Re: 09-AFC-6 Blythe Solar Power Plant Project

TESTIMONY OF MATTHEW F. HAGEMANN
ON BEHALF OF CALIFORNIA UNIONS FOR RELIABLE ENERGY
FOR THE BLYTHE SOLAR POWER PROJECT

Figure 1: Project Location Map, FUDS and Ranges

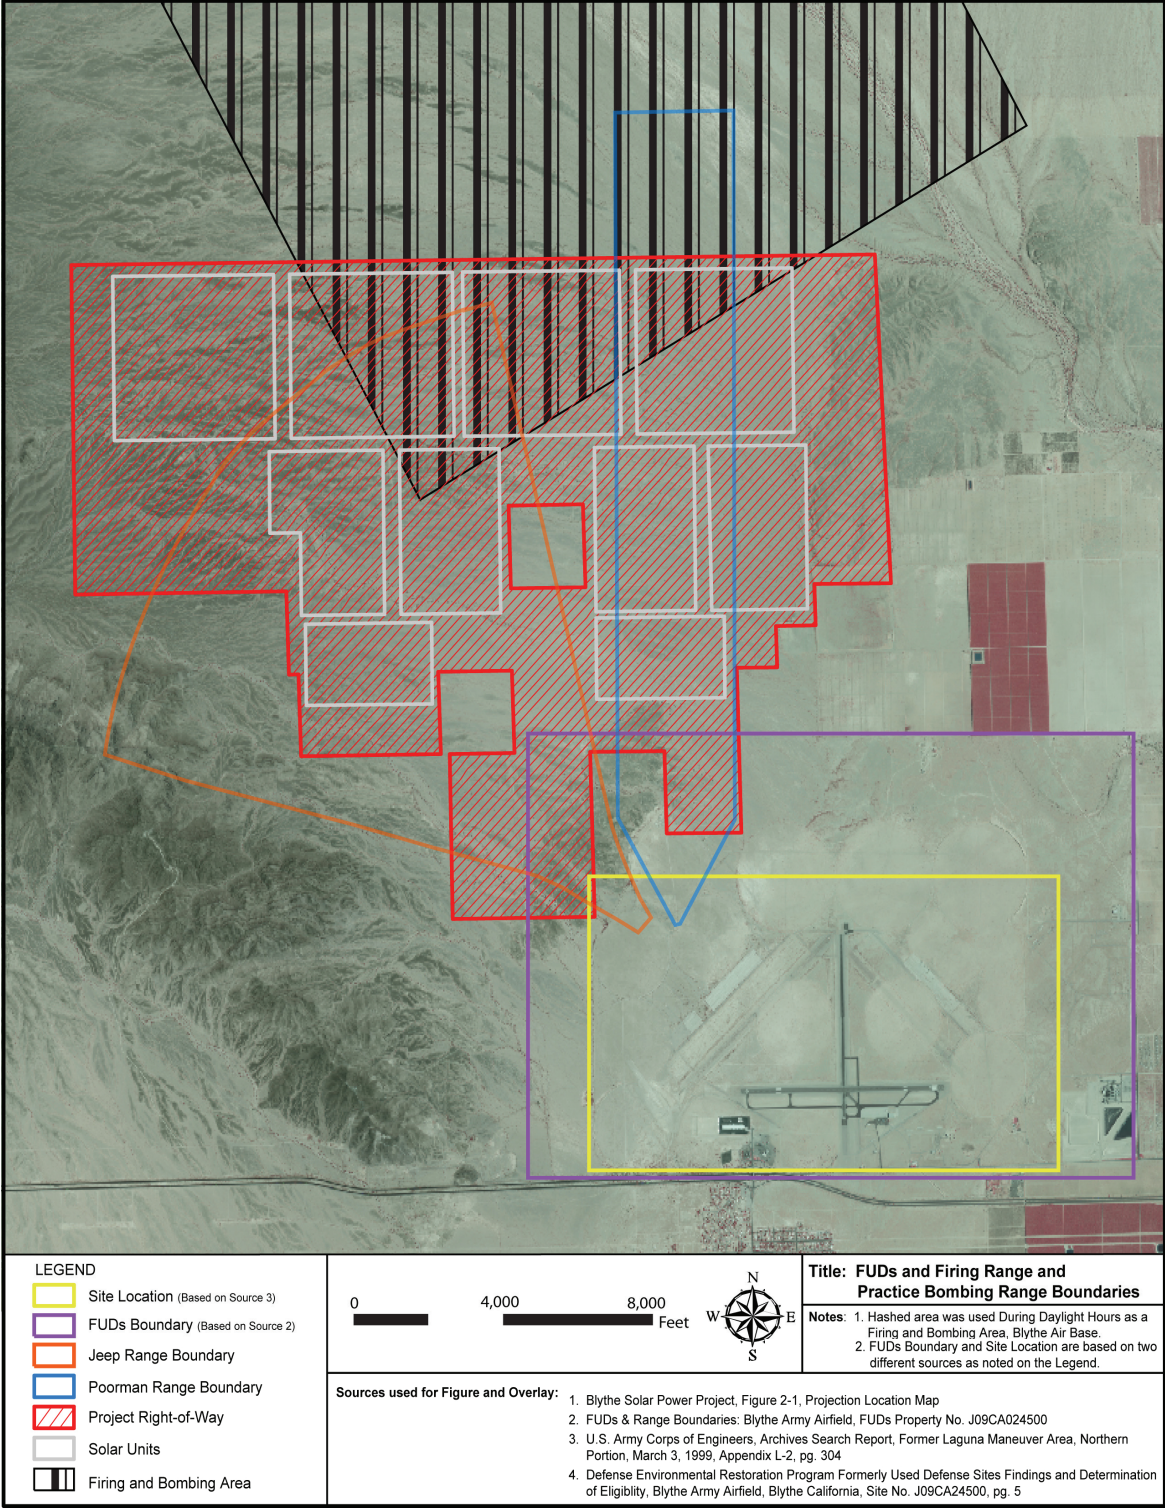
Poorman ranges were used at bases across the U.S. for training in aerial gunnery. The ranges were developed to simulate conditions encountered by aerial gunners. The gunner learned turret operations and safety procedures while firing at silhouettes of a fighter that moved toward trainees on a track. The turrets generally had twin-mounted .50 caliber machine guns. The range fan associated with the Poorman Range at the Blythe Army Airfield is shown below in Attachment 7, Figure 1 to extend more than 4 miles into the Project right of way.

The range fan associated with the Jeep Range at the Blythe AAF is shown below in Attachment 7, Figure 1 to extend 3 miles into the Project right of way.

The Applicant identified the Poorman and the Jeep ranges to be within the Project boundary in responses to Staff's data requests.²⁷ However, the Applicant and Staff failed to identify and analyze the range fans, or safety areas for the Poorman and the Jeep Ranges that would extend almost across the entire Project area.²⁸

Presumably, Staff drafted WASTE-1 and WASTE-2 without knowledge of the safety fans associated with jeep range and Poorman ranges, or evidence and parameters of the Firing and Bombing Area on the Project site. Typically, where such hazards are known, extensive geophysical surveys would be conducted under regulatory oversight well in advance of earthmoving activities. Such surveys require that a project site be systemically traversed by vehicles using GPS to document the areas that have been assessed.⁴⁸ The location of debris is marked and the debris evaluated and removed if determined to be inert. Any potentially live ordnance would be marked for proper evaluation and detonation. Such evaluations must be completed prior to the start of any construction to avoid potentially significant risk to worker safety. Staff must specifically require in the condition of certification that the Applicant undertake the appropriate

surveys, testing, removal, and closure actions on the entirety of the Project disturbance area before construction can begin. In my opinion, given the extensive military use as a Poorman Range, a Jeep Range and a practice bombing range, it is not possible to begin earth moving activities without compromising worker safety until the entire Project disturbance area has been surveyed for UXO and the soil has been sampled for chemical constituents.
